CORRECTIVE MEASURES STUDY ADDENDUM SOLID WASTE MANAGEMENT UNIT 54
WITH TRANSMITTAL AND RESPONSE TO COMMENTS NAVAL ACTIVITY PUERTO RICO
6/1/2012
AGVIQ/CH2M HILL

RE: Contract No. N62470-08-D-1006
Task Order No. JM04
Solid Waste Management Unit (SWMU) 54
Naval Activity Puerto Rico - Ceiba, Puerto Rico
Corrective Measures Study Addendum for SWMU 54 Benzene and Ethylbenzene Plume

| Responses to Comments Summary | |
| Document: | <i>Corrective Measures Study Addendum SWMU 54 Benzene Plume and the Corrective Measures Implementation Plan SWMU 54 Benzene Plume</i> , Naval Activity Puerto Rico (NAPR), EPA ID PR2170027203, Ceiba, Puerto Rico, dated January 2012 |

FIGURE 1-2
 Site Layout
 SWMU 54
 Naval Activity Puerto Rico

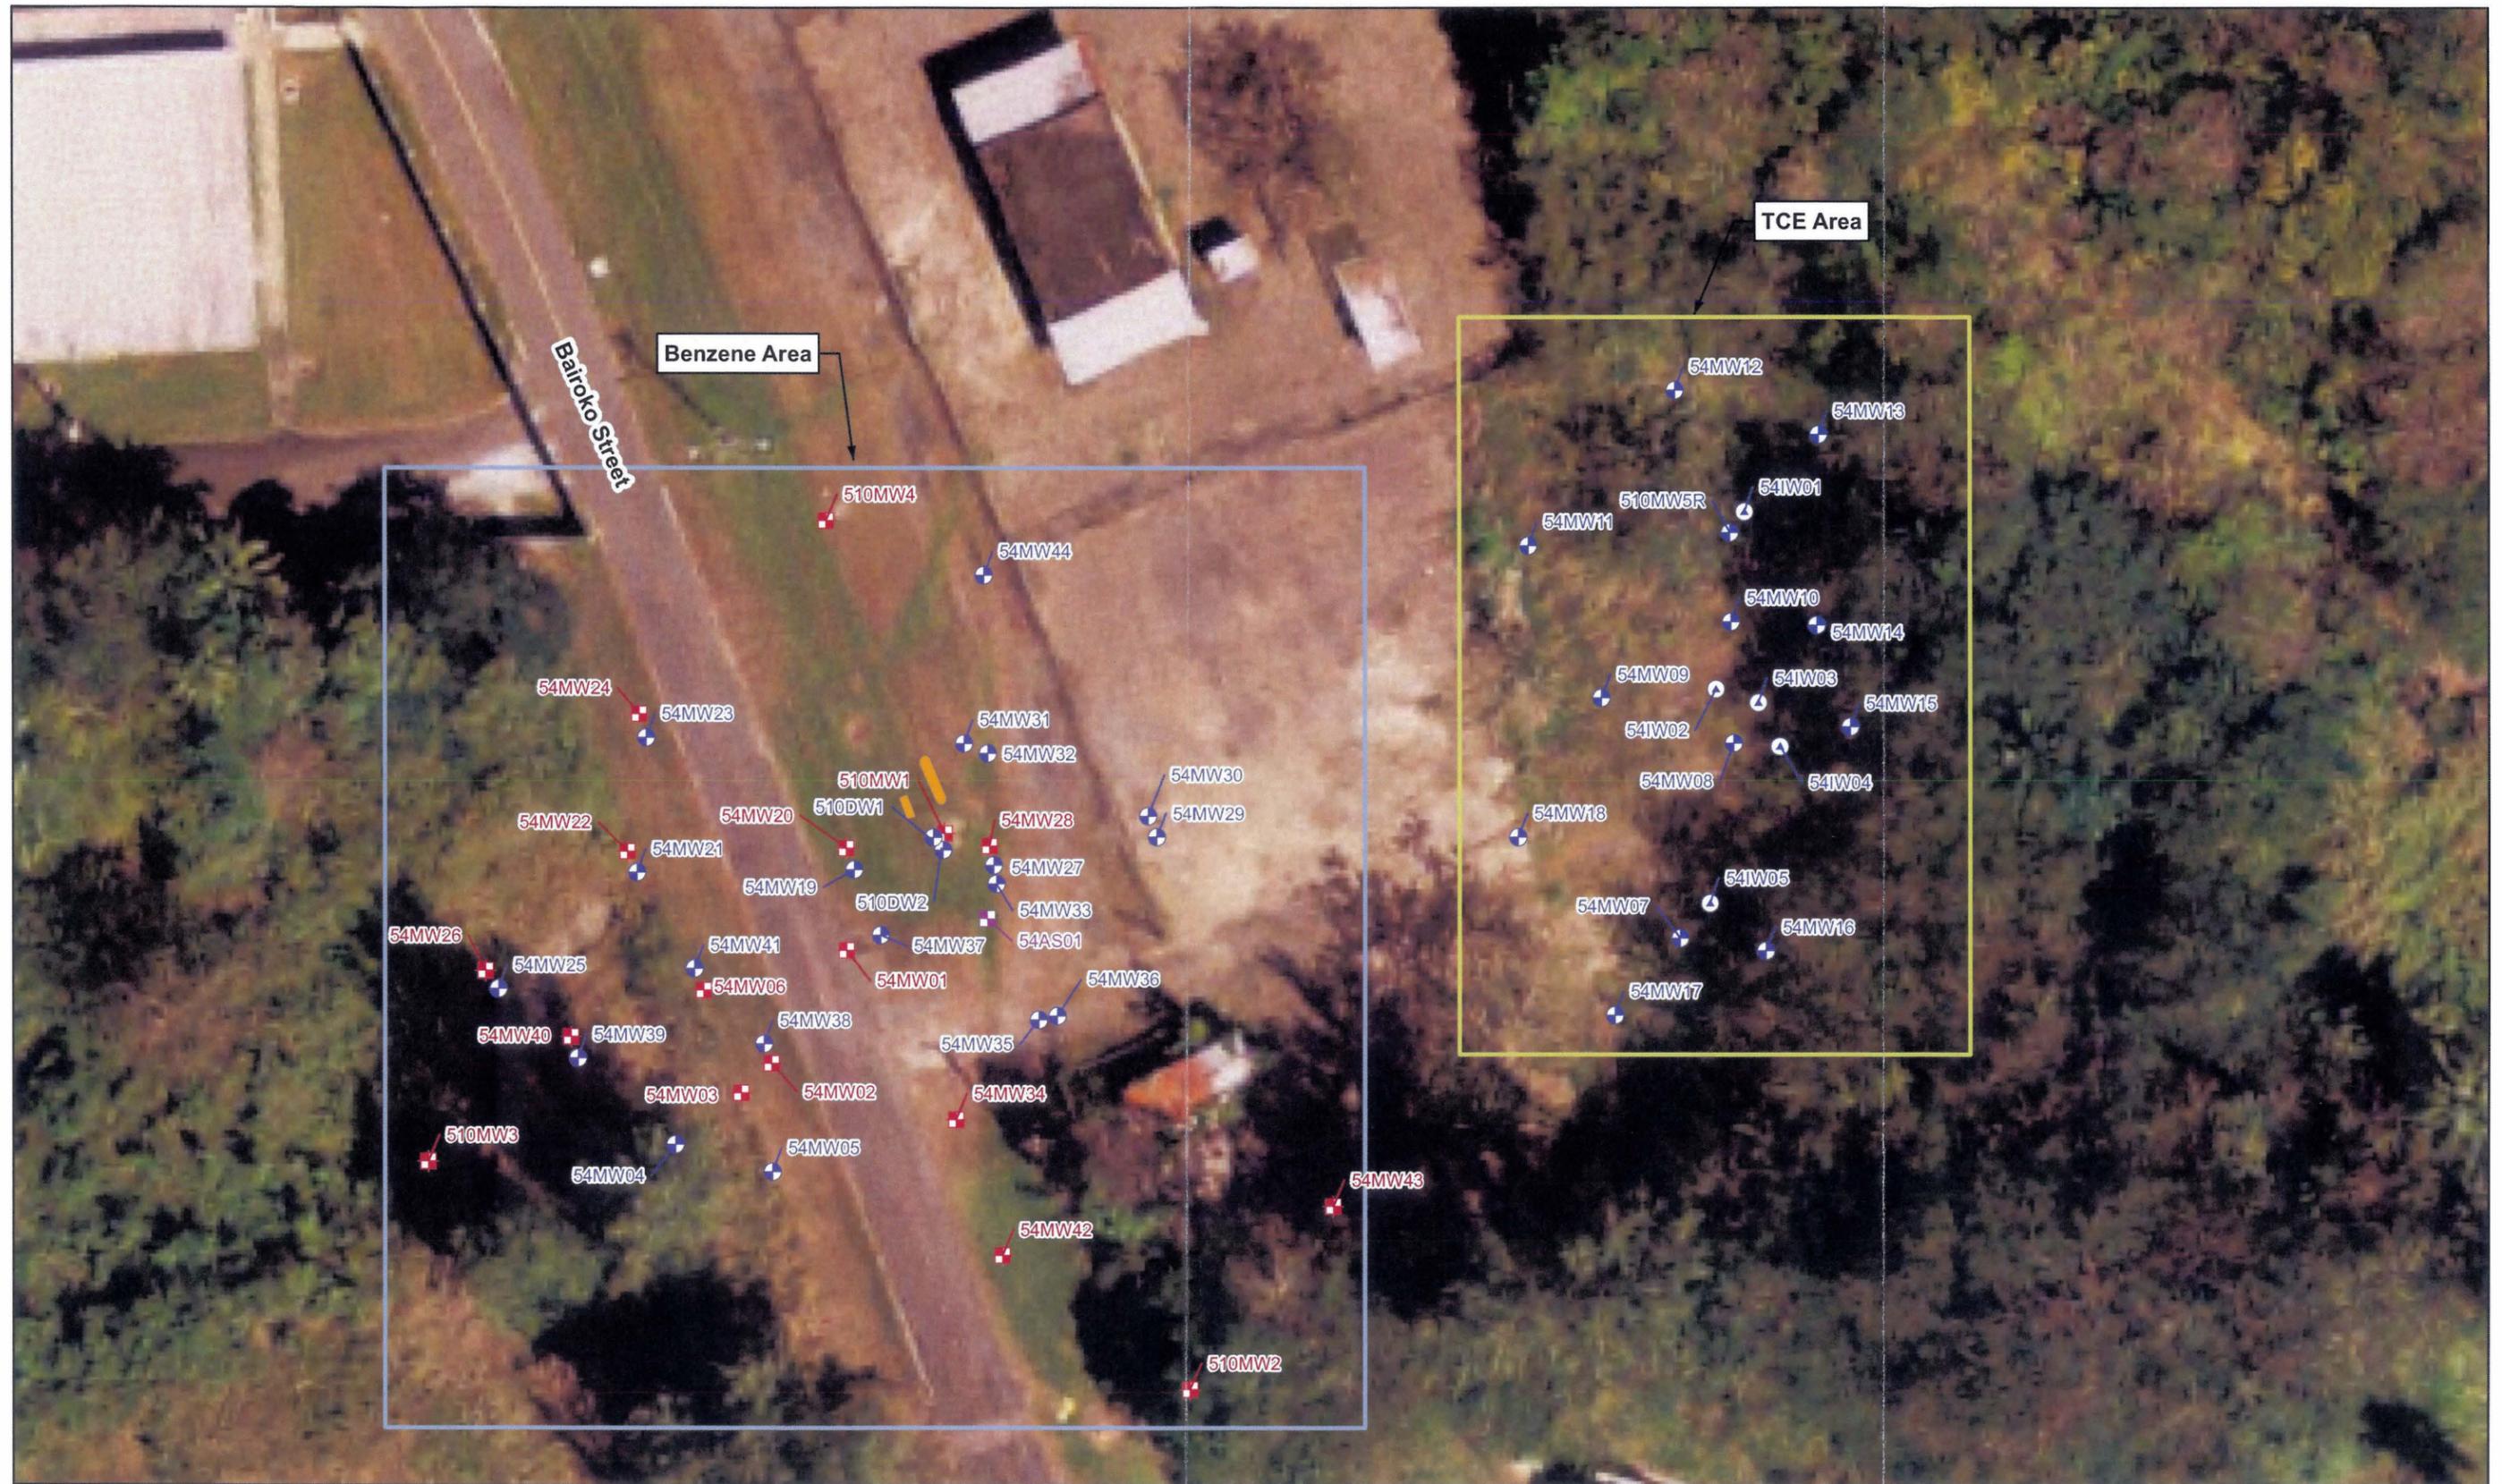
Evaluation of Response to EPA Specific Comment 2: The response addresses the comment with additional clarification required. The groundwater flow direction is presented only in Figure 3-3, Appendix A, Pilot Scale Test Report, of the CMS Addendum Rev. 01 and not in CMS Addendum Figure 1-2, or in Figure 1-2 in Appendix A as indicated in the response. Revise CMS Addendum Figure 1-2 to include the groundwater flow direction.

The arrow showing direction of groundwater flow is presented in the bottom left corner of Figure 1-2. The figure was not revised.

FIGURE 1-4
Benzene Concentrations Exceeding Corrective Action Objective August 2009 Through October 2010 SWMU 54
Naval Activity Puerto Rico

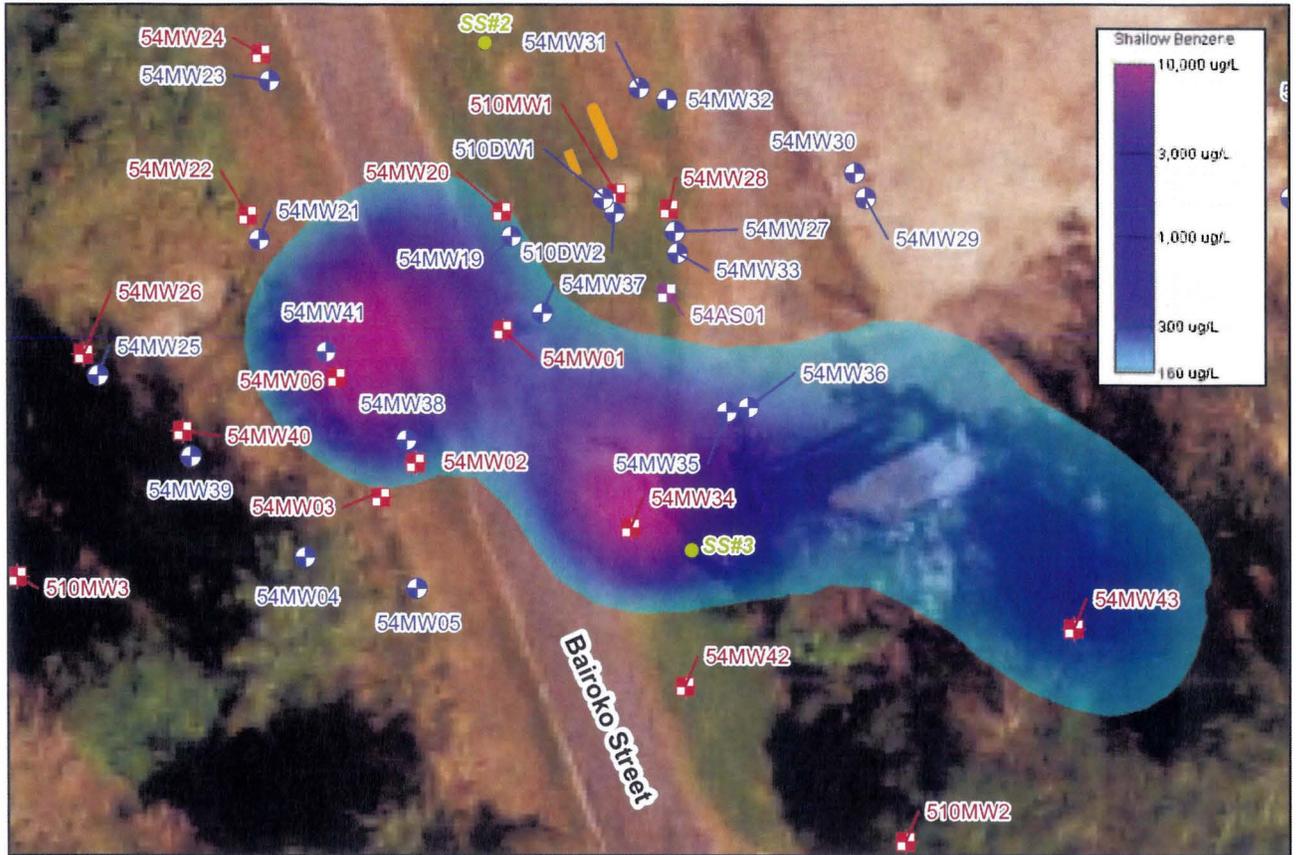
1. Page 1-6, Section 1.2, Bullet 2: Please clarify that when referring to VOC concentrations observed, it is referring to VOC air monitoring at the storm sewer monitoring location SS#3. Also, the storm sewer monitoring locations should be depicted in a Figure.

The text (now on Page 1-8, Section 1.3, Bullet 1) was adequately clarified. Please notice that the vapor monitoring locations were added to Figure 1-4 instead of Figures 3-1 and 3-2. Actually, there are no Figures 3-1 and 3-2 on the current version of the document.

The text has been clarified to indicate that observed VOC concentrations are those observed at underground utility structures. Vapor monitoring locations (SS#1, SS32, SS#3) were added to Figure 3-1 and 3-2.

Comment acknowledged.
